Case No.:	ADM-2024-7827-PMUL-HCA
CEQA:	N/A
Address:	4457 South Berryman Avenue
Council District:	11 – Park
Neighborhood Council:	Del Rey
Community Plan Area:	Palms – Mar Vista – Del Rey
Specific Plan:	Los Angeles Coastal Transportation Corridor
Land Use Designation:	Low Residential
Zone:	R1-1
Legal Description:	Lot 25, Tract TR 3901

LETTER OF CORRECTION

LETTER OF COMPLIANCE – Ministerial Review of SB 9 Urban Lot Split

Layouts (323)-979-8442 office@layouts.homes	PARCEL MAP FOR URBAN LOT SPLIT SUBDIVISION PURPOSES SCALE: 1" = 20'-0" 4457 S BERRYMAN AVENUE, LOS ANGELES, 90230	A1 11/04/24

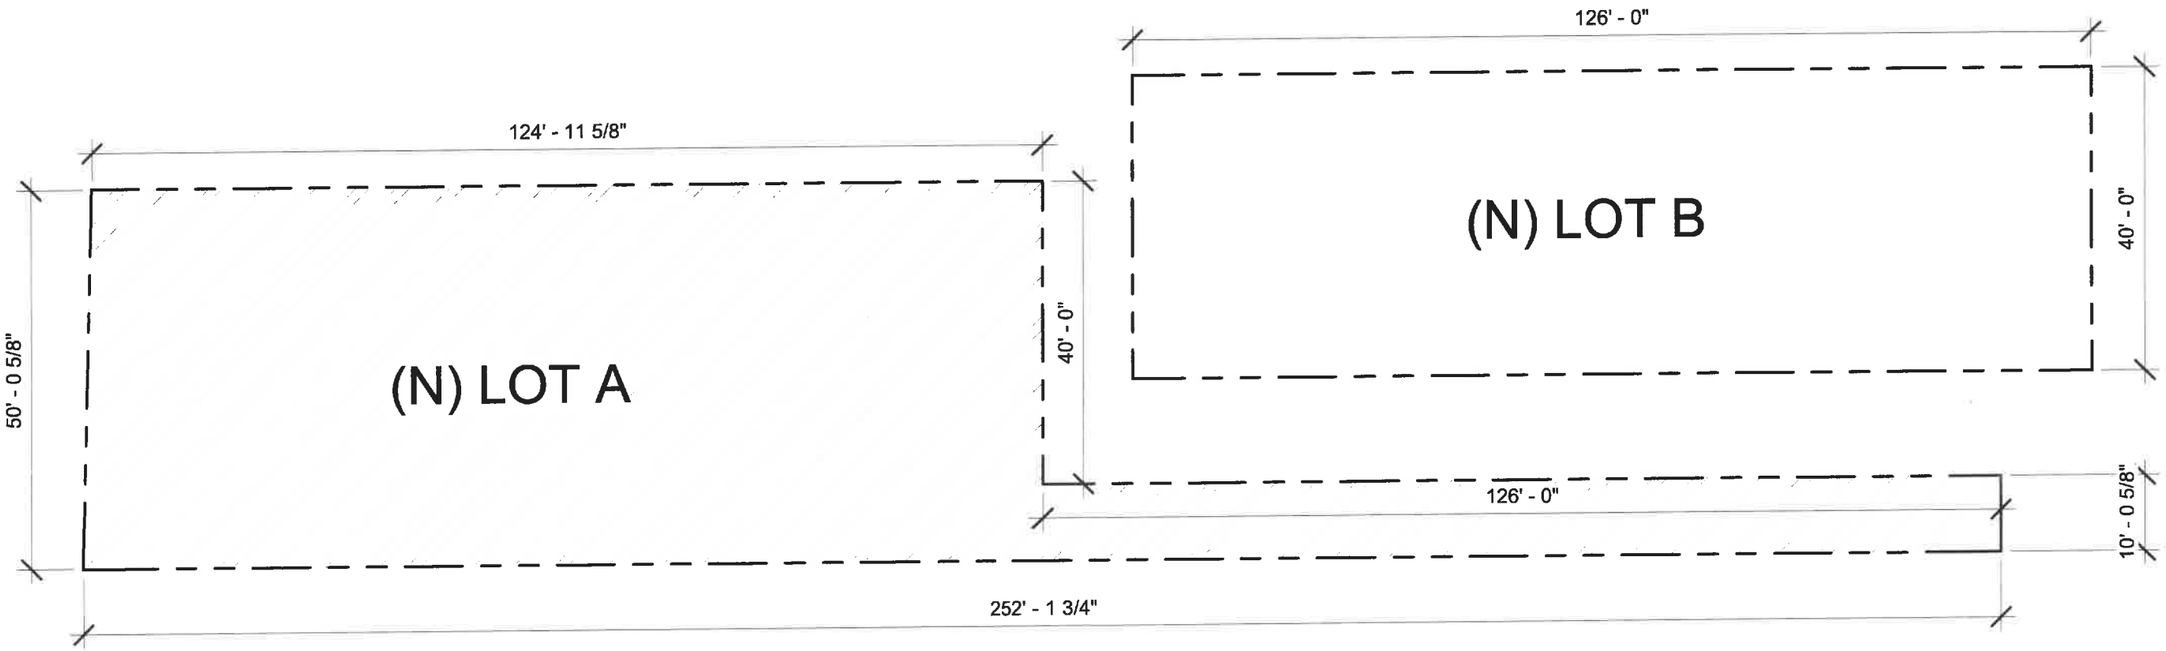
c. No resulting parcels may be smaller than 40 percent of the lot area of the original parcel proposed for subdivision or smaller than 1,200 square feet. The proposed Lot B is 39.997 percent of the original lot area. Revise the Map to show compliance with the above requirement.

d. The following items do not comply with the current Zoning requirements. Revise the map or obtain approval from the Advisory Agency to approve for the deviations from the Zoning Code.

i. The proposed Lot B does not provide the minimum required 20 ft. street frontage to the public or private street and the minimum required 20 ft. access strip width as required by the definition of a “lot”.

ii. The proposed Lots do not provide the minimum required 50 feet of lot width for R1 zone per LAMC Section 12.08 C.4.

1. The proposed Parcel A and Parcel B are permitted to deviate from the minimum lot width (50 feet) requirements of the R1-1 Zone pursuant to LAMC 12.08 C.4.

2. The Advisory Agency approves a street frontage and access-strip of 10 feet 5/8 inches for Parcel B in lieu of the minimum street frontage and access-strip width of 20 feet required by the definition of a “lot.”
